OPL1000 A1 DevKit

Title			
History			
Size A	Document Number <Doc>		Rev V1.0
Date:	Monday, July 02, 2018	Sheet 1 of 2

OPL1000_A1_DevKit		
Size B	Document Number	Rev 1.0a
Date: Monday, July 02, 2018	Sheet 3 of 3

ICE interface

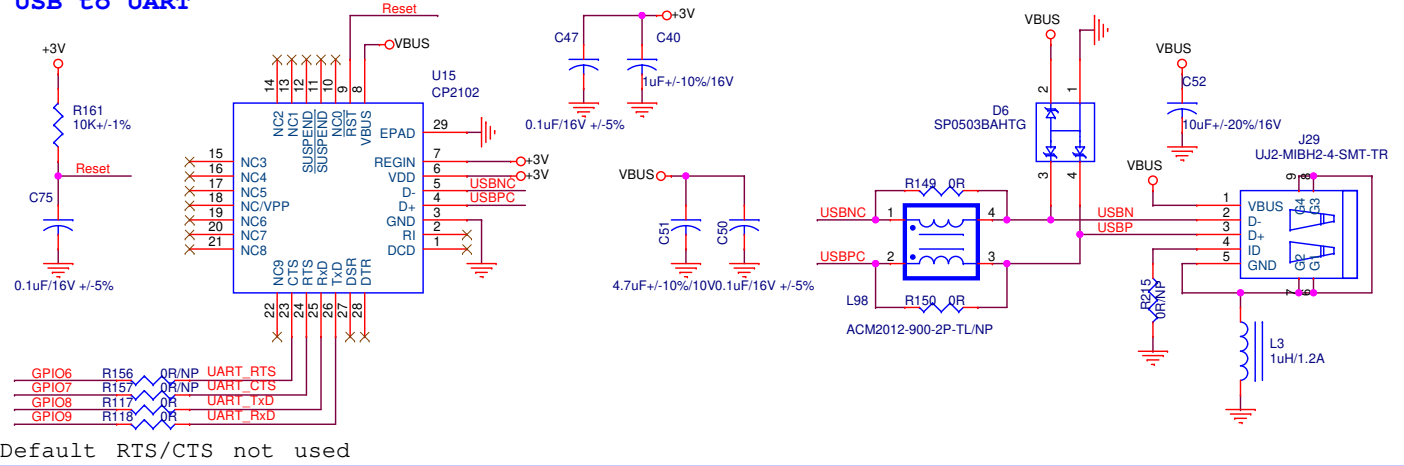
5	4	3	2	1
Date	Description			
2018/06/21	1. Add Rx1,Rx2,CX1,CX2,CX3,CX4 for ICE interface issue 2. Add TP1			
D				
C				
B				
A
